CONSTRUCTION VALUE ENGINEERING CONCEPT PROPOSAL  
MISSOURI DEPARTMENT OF TRANSPORTATION

Job No. J1Q2160

*VE # 08-32*

**MoDot DMS Support  
MO  
Project No.: 07059**

**DMS POST**  
2 PER SITE

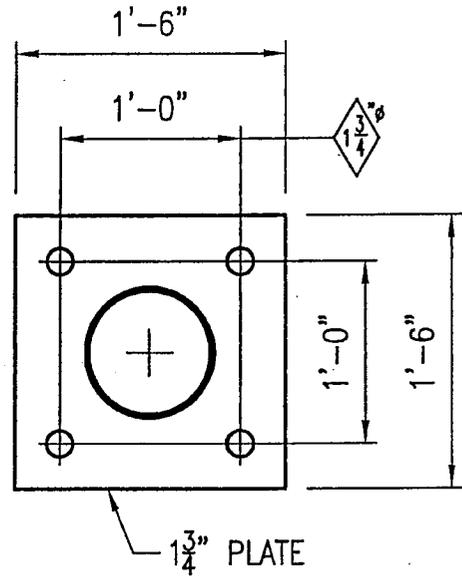
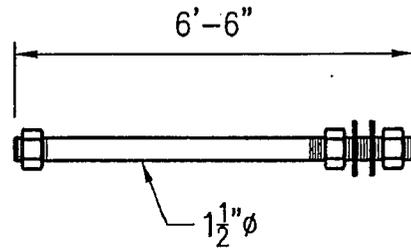
I have reviewed the VE proposal and it is my understanding that the VE proposal changed the post size from a 12 inch diameter steel post to an 8 inch diameter or 10 inch diameter steel post depending on the height of the steel post. In addition the proposed base of these steel posts was modified from ring stiffened base to a base that included no stiffeners.

I have reviewed the Design Calculations that were provided by Cowell Engineering and the calculations appear to be incomplete. Because these dynamic message signs weigh over 2000 pounds and have a thickness of three to five feet, the steel posts and base plates cannot be designed using Design guides for thin and flat signs. Torsional loads, aerodynamic forces and deflections induced by wind must be carefully evaluated. Truck induced wind gusts and vortex shedding cause vibrations and fatigue and must be carefully evaluated. The connection method of attaching the DMS to the support structure is also important and must be addressed by the engineer. I could find no reference to any of these above mentioned important design requirements in Cowell Engineering's Design Calculations.

According to NCHRP Report 411 both Virginia and California have experienced failures of Dynamic Message Sign supports. We recommend that:

As stated below in December 2007, Bryan Hartnagal and the original designer from Parson's & Brinckerhoff reviewed the design calculations. At this time Parson's & Brinckerhoff had some concerns with Cowell Engineering's design computations and recommended that the original design be used and not the value engineered design.

*The Dynamic Message Signs that have already been constructed using this value engineered design be carefully monitored by the district.*

*A detailed analysis be performed to determine the expected fatigue life of these Dynamic Message Sign supports and support structure. Within 3 to 6 months Bridge Office can perform a detailed analysis of these modified supports.*

*No more value engineering proposals be approved for this modified DMS supports until it is determined if these modified supports and connection method to support structure are designed to support the expected torsional loads, aerodynamic forces and fatigue.*

Contractor proposed to substitute 8" and 10" std pipe for the 12" as designed. This has previously been approved on other projects; however it is rejected based on analysis done by the Bridge Division.
